TOWN AND COUNTRY PLANNING (SCOTLAND) ACTS - PLANNING APPLICATION: 2015/0305/DET. ERRECTION OF OFFICE ACCOMODATION SAWMILL BALLIEMEANOCH, STRACHUR, ARGYLL AND BUTE, PA27 8DW.

Following receipt of the SEPA response (PCS/145953) dated 6th April 2016 and their maintained objection with respect to the above project we are pleased to provide the following comments and additional information.

PROVISION OF OFFICE ACCOMM OLD STRACHU	ODATION	MENT /	- PMCKERRAL 5 CO CAMPELLTOWN
STRACHUR	ARGYLL	for -	
PROPOSED SITI	EPLAN		
SCALE: 1/200			AUGUST 2015

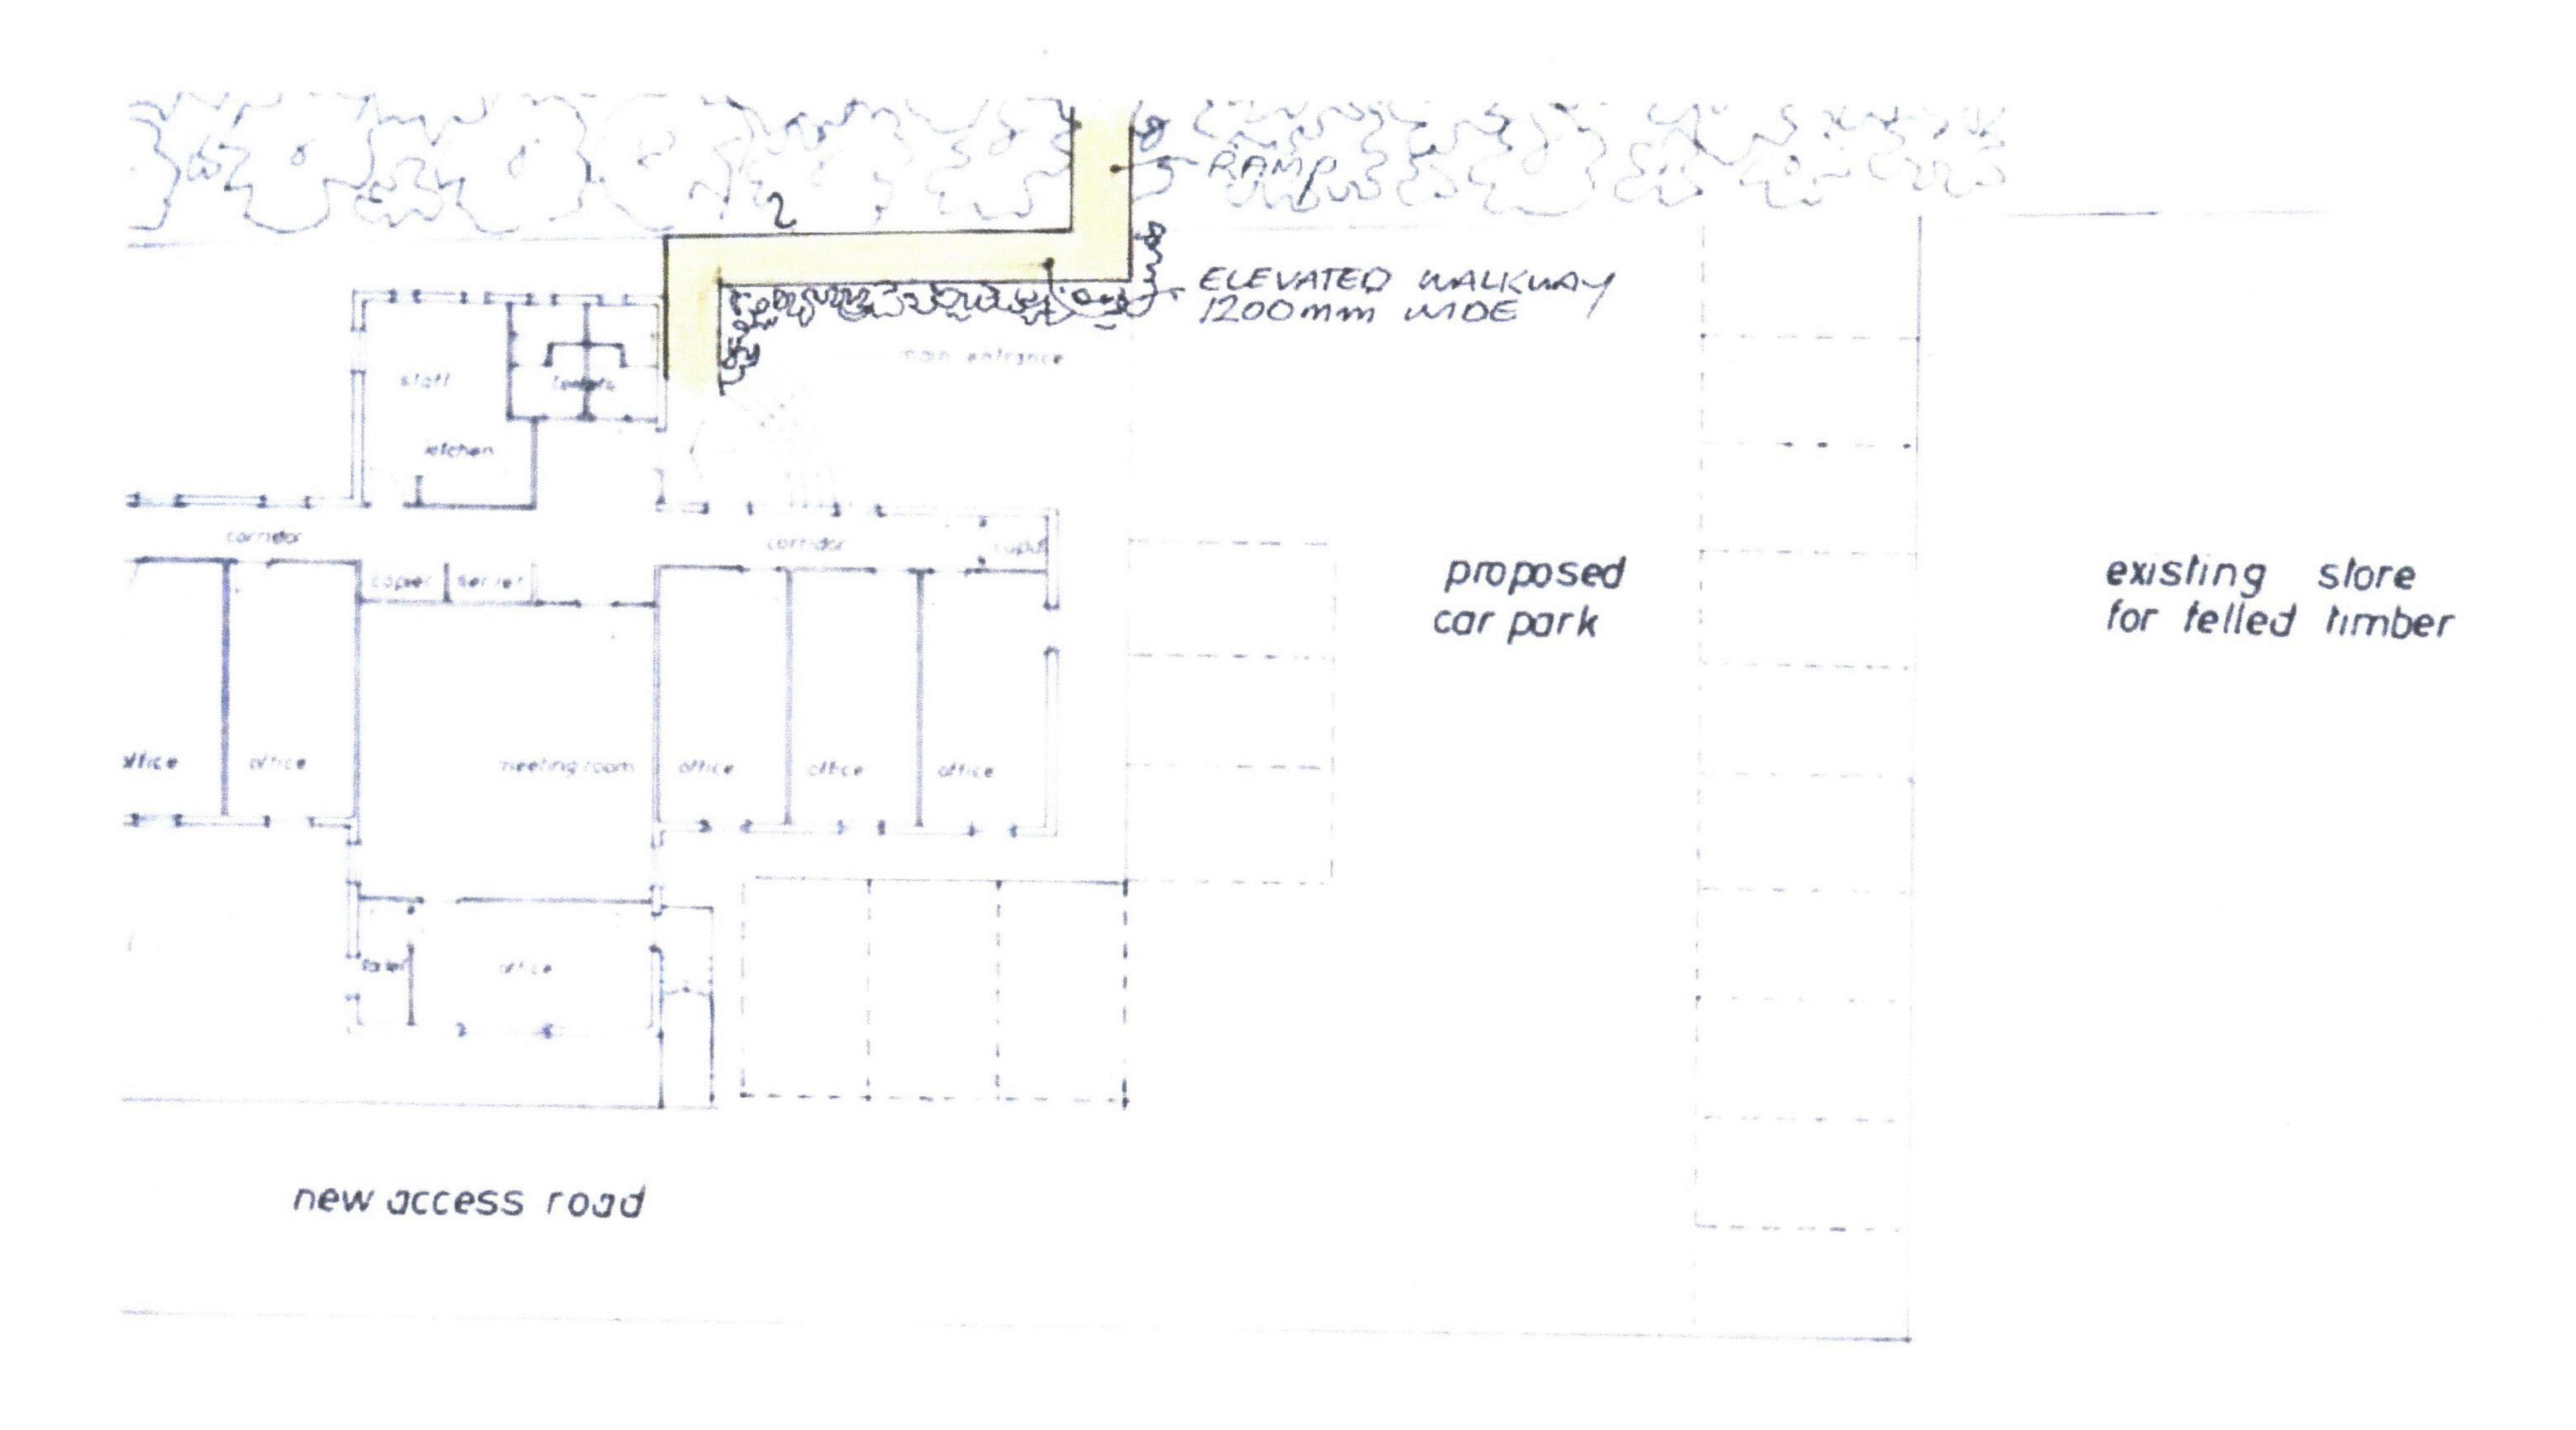
Within the SEPA response, in sub-section 1.7, SEPA make reference to concerns over the provision of safe (i.e. dry) pedestrian access/egress from the proposed development.

Following discussions with the client and the architect for the project, we propose that dry pedestrian access/egress can be provided at the site via the provision of an elevated walkway. A revised site plan has been enclosed with this letter report, showing the proposed elevated walkway linking the main entrance to the office with the road embankment of the A815. The A815 is out-with the functional flood plain of the River Cur and is dry throughout the design storm event. The local topography north of the site, between the site and Strachur is noted to climb significantly with an approximate height gain of around 10m. This route would provide safe (dry) pedestrian access and egress throughout the peak storm event.
